N5247A-02A

S E R V I C E N O T E

N5247A PNA Series Microwave Network Analyzers

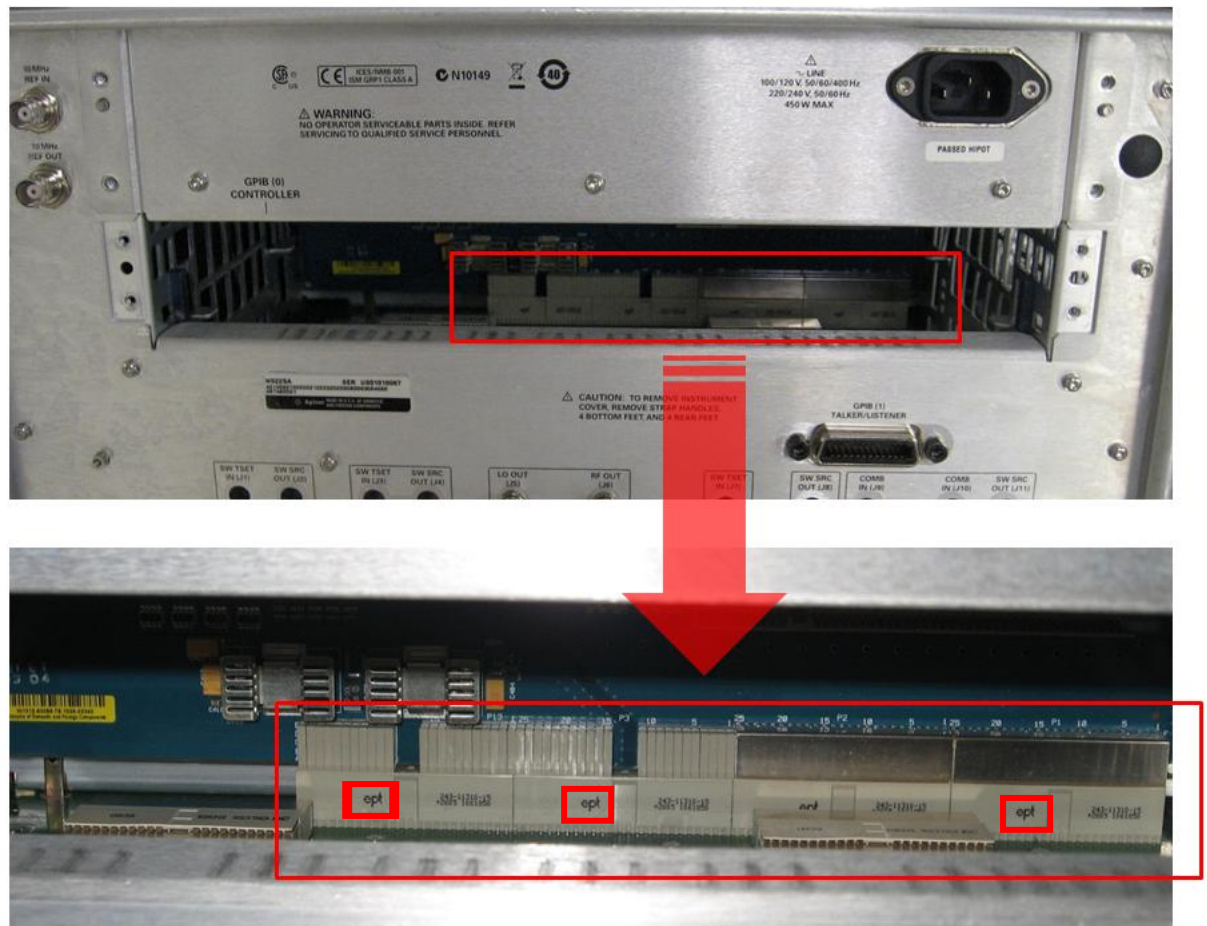
1. Remove the CPU assembly from the analyzer's rear panel. Refer to the PNA Service Guide chapter 7 section titled, "Removing and Replacing the CPU Board Assembly" for removal and reinstallation procedures. To view the online Service Guide, see the numbered list on the next page for instructions.
2. As per the photo below, inspect the system motherboard connector to see if it has one or more "ept" logos.

3. If the connector has one or more “ept” logos, return the analyzer to Agilent for replacement of the system motherboard. If the connector does not have one or more “ept” logos, email ctd-soco_support@agilent.com, providing the analyzer model and serial number and details of the malfunction symptoms.

4. *For Agilent Service Technicians only:* Only new boards without “ept” logos should be installed. Before installing the new board, look to see if it has one or more “ept” logos. If so, email ctd-soco_support@agilent.com, providing the analyzer model and serial number. Wait for further instructions in an email reply. New boards without “ept” logos can be installed. For installation instructions, refer to the PNA Service Guide chapter 7 section titled, “Removing and Replacing the System Motherboard.” To view the online Service Guide, see the numbered list on the next page for instructions.
